SUBJ: Polaris at Totem Lake project

RE: Response to Joseph Tovar's letter dated 9/27/2022

City of Kirkland Design Review Board  
123 Fifth Avenue  
Kirkland, WA 98033  
SUBJ: Polaris at Totem Lake project

## COMMON OPEN SPACE

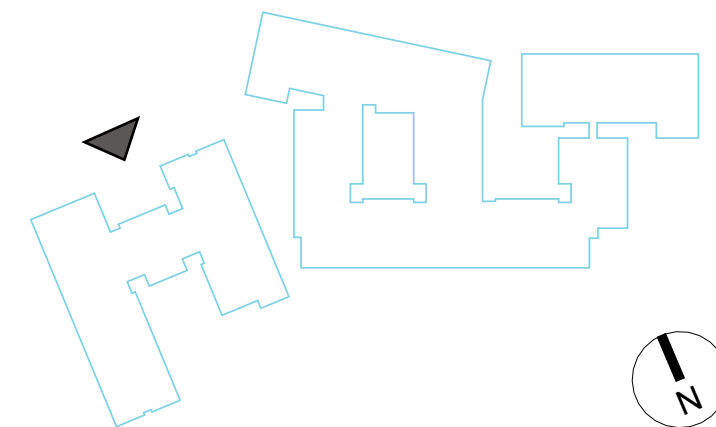
The DRB discussed the open spaces proposed on by the project, particularly the public pedestrian plaza located in front of the commercial space along 120th Avenue NE. The Board encouraged the applicant to study that space and expressed concern about its usability given the northerly orientation.

## EVERGREEN ACADEMY / DEVELOPER MEETING SUMMARY:

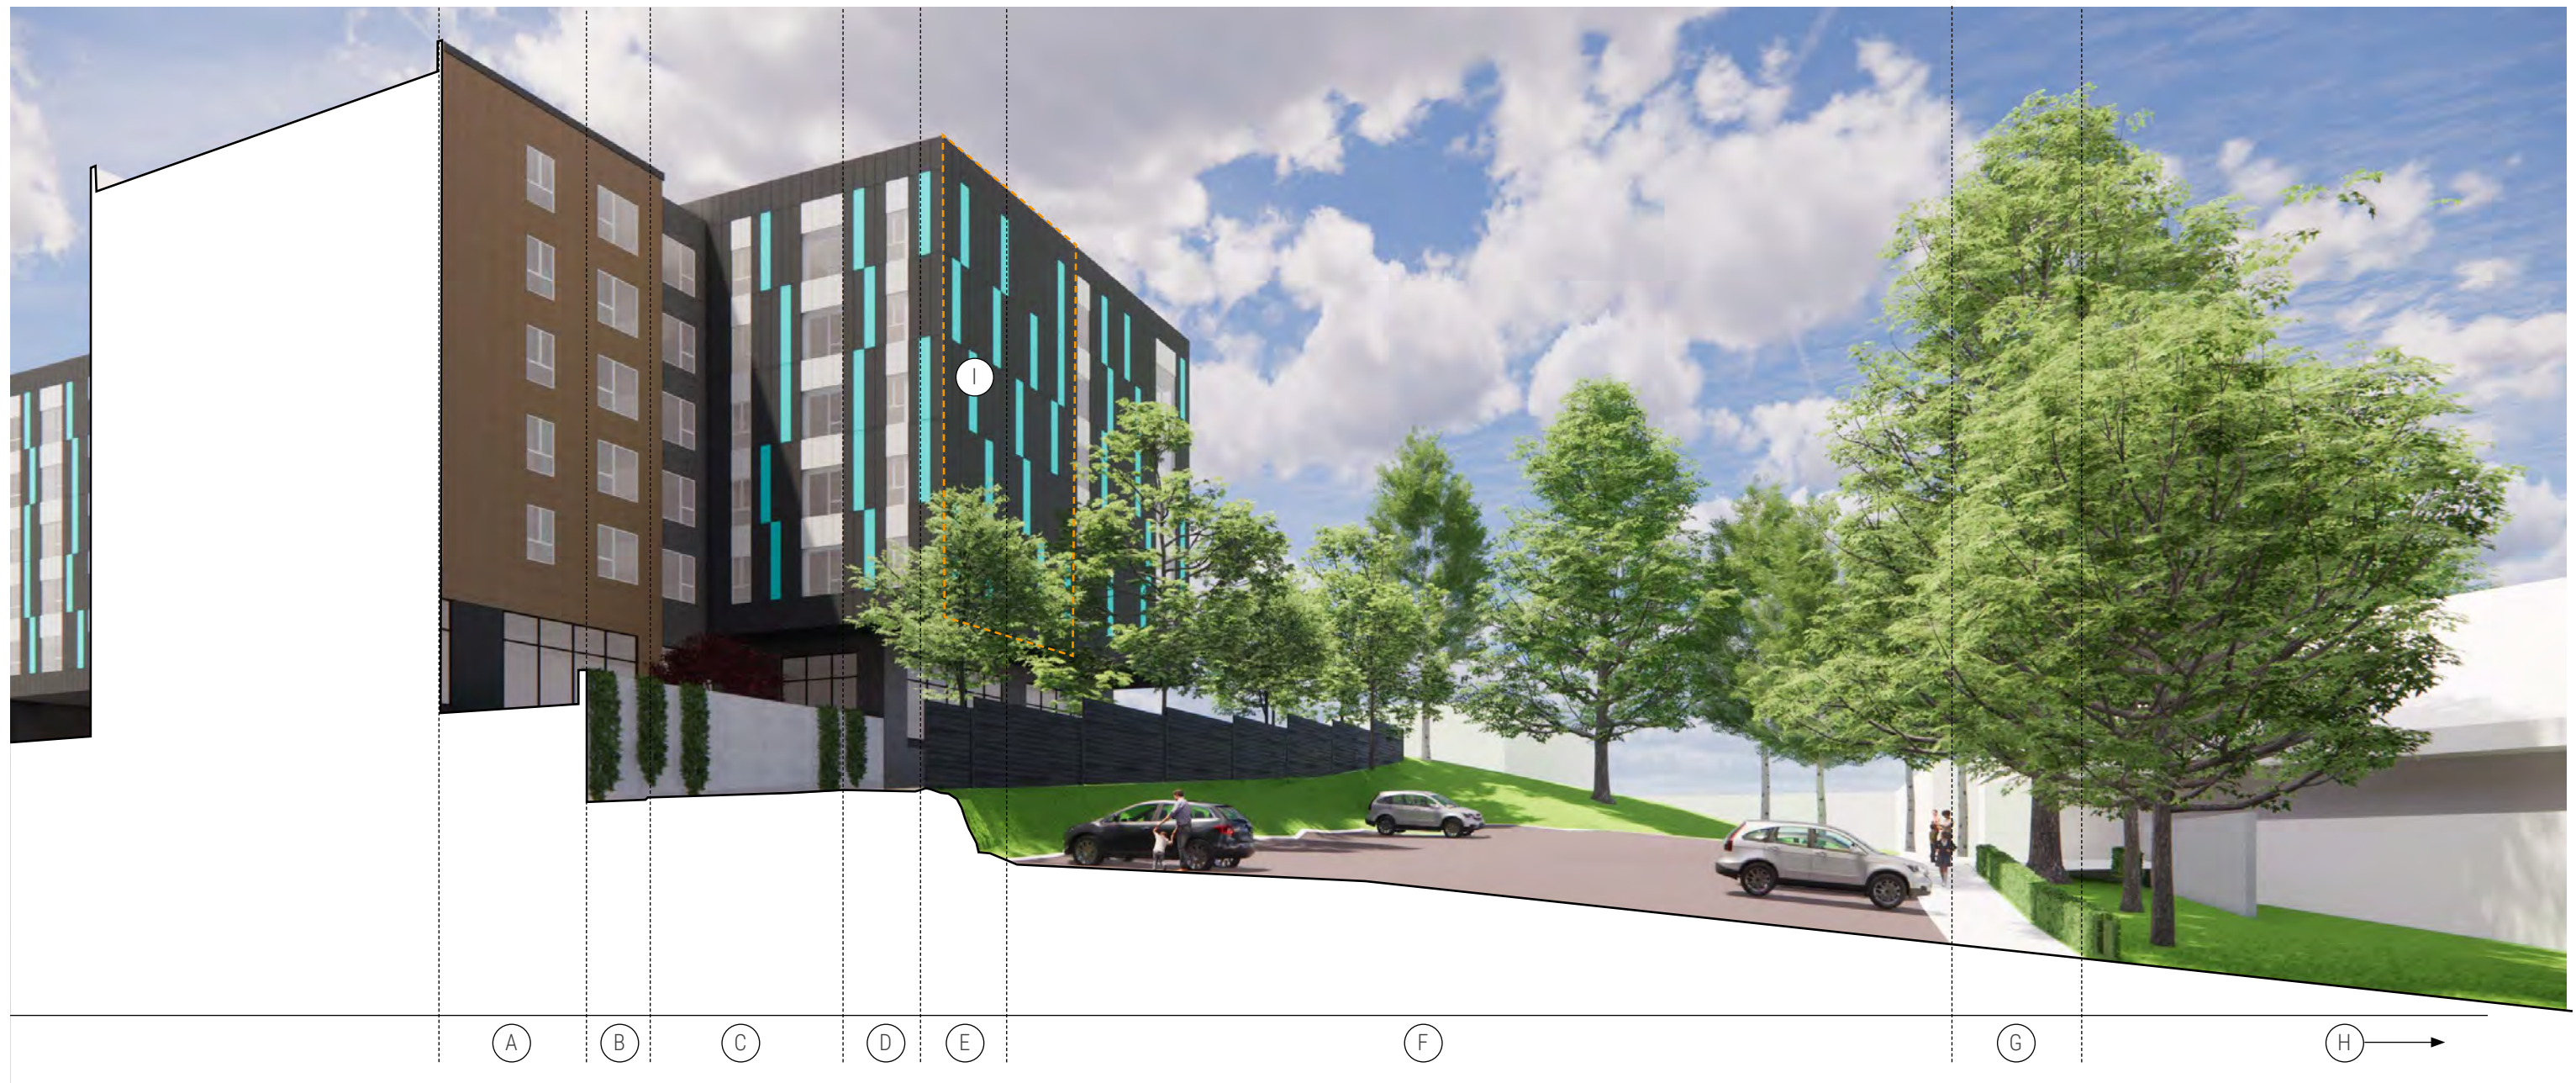
The neighboring property owner directly to the North of the proposed project, the Evergreen Academy, expressed concerns with the following items during the Conceptual Design Conference process:

- 1.) Sight lines from the proposed project down and into the playground areas
- 2.) The scale and proximity of the proposed project to their building
- 3.) The retention of existing trees between the two properties which currently act as a screening wall
- 4.) The potential shadows the project will cast upon their project once completed.

- (A) Tower B residential courtyard positioned in this location to help provide a visual buffer as well as reduce the scale of the building in proximity to the Evergreen Academy
- (B) Tower B resident access / planting strip
- (C) Fire Lane (Emergency Vehicle Access only)
- (D) Planting Strip/ Required Landscape Buffer which includes existing mature trees to remain (on our property)
- (E) Existing site retaining wall
- (F) Evergreen Academy parking lot
- (G) Evergreen Academy sidewalk / site circulation
- (H) Evergreen Academy playground beyond
- (I) Intentional limitation of prime residential views in order to limit sight lines onto the adjacent property - Evergreen Academy

**Attachment A – Playground, trees, towers**

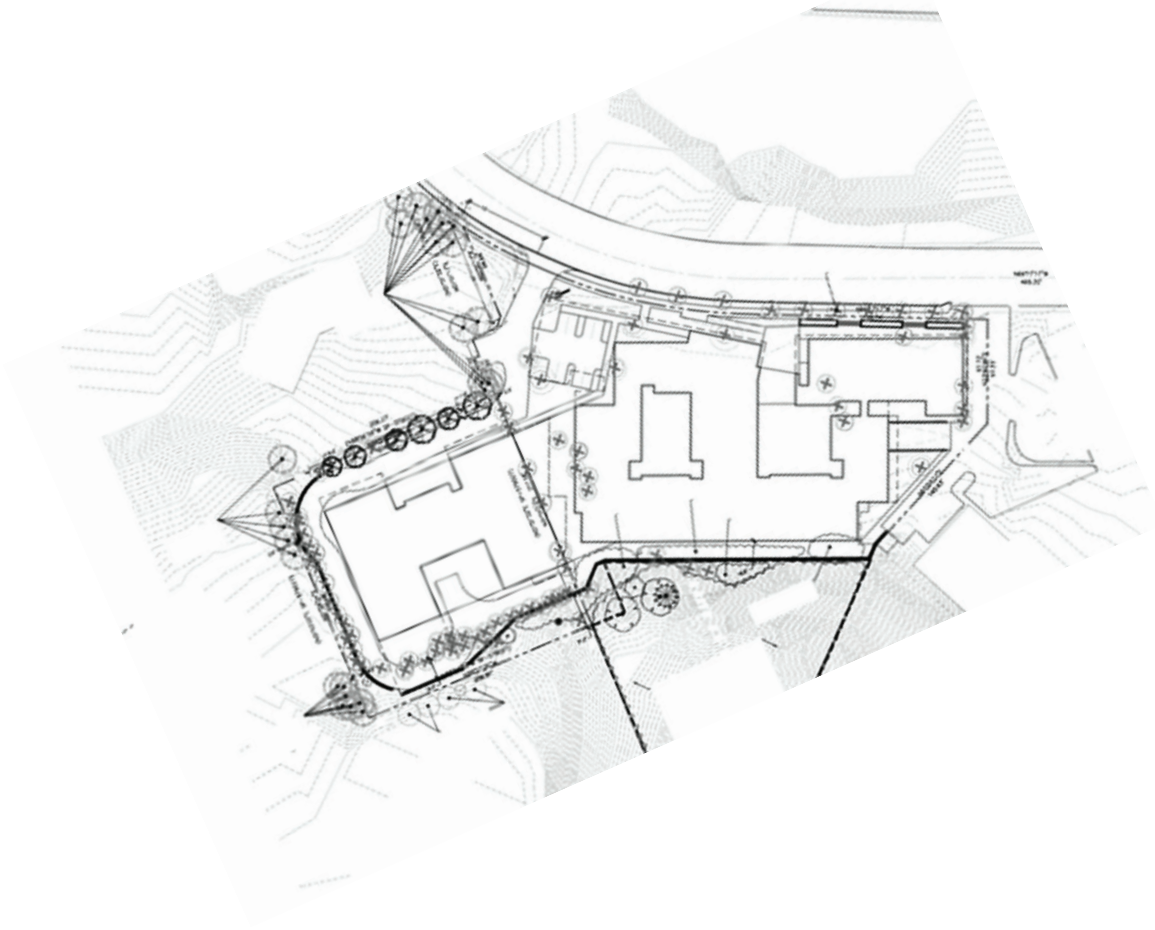
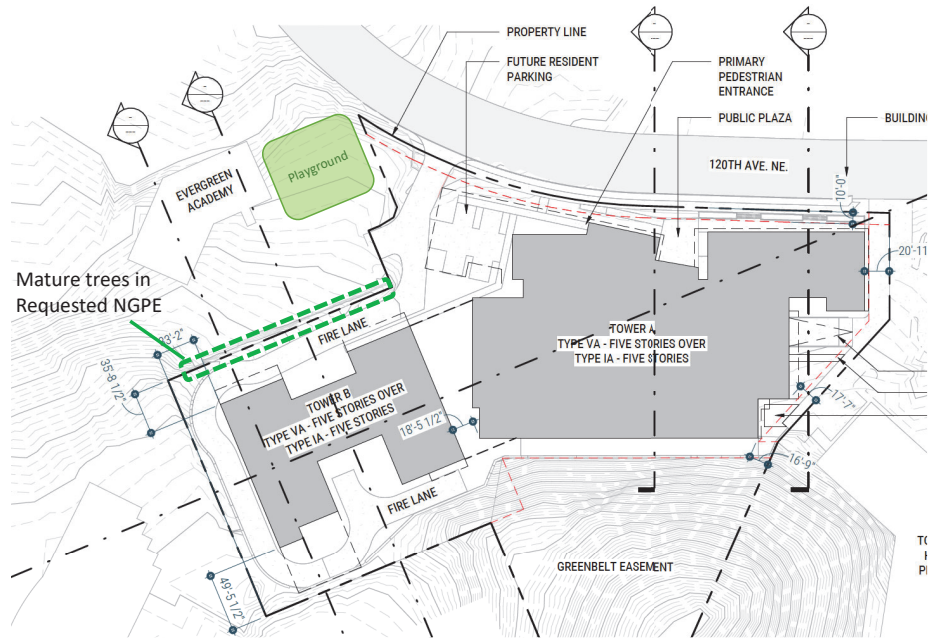
At any point during the day, there are up to forty children, ages 2 to 6, using the open playground at the east end of the Montessori School. The proximity of the Polaris Towers to the property line will create lines-of-sight between the windows of the units and the open-air playground. See Attachment A.

*To make the directness of these lines-of-sight apparent, we recommend that the DRB have the Inland architect show these lines-of-sight on the computer model with the tree layer turned off and the Polaris Towers and Montessori playground intact. Showing the DRB this information will make apparent why, for reasons of privacy and security, we have asked that windows, facade details or other design treatments be incorporated into these building facades to minimize the lines-of-sight.*

*The responses by the applicant so far do not appear to accomplish this objective. We therefore recommend that the DRB direct the applicant to develop and incorporate architectural modifications or additions to the windows and facades to limit the open views between both Towers and the Montessori School playground.*

The concern of views to the playground has been a topic we have been discussing and addressing with the Bedford's since October 2021. As a result of those discussion and the Bedford's concerns, we have designed our community to reduce the total number of units with views towards EMS. Out of our 442 planned units, only 34 units (less than 8%) are located along the shared property line. Out of the 34 units along our shared property line, 10 units have no views to the playgrounds, 16 units have filtered views of the playground, and 8 units have direct views (less than 2% of total units). The reason that only 8 units have direct views to the playground is because we have listened to the Bedford's concerns, accommodated their requests, and mitigated the impacts (at significant cost). Given our significant mitigation efforts and the reduced scale of impact (2% of total units), we do not believe additional mitigation is warranted, particularly a large change to our massing concept that was approved by the DRB. Also, with regards to the Tower B courtyard, that amenity is located on the third floor from grade, and it will not have access to the fire lane below.
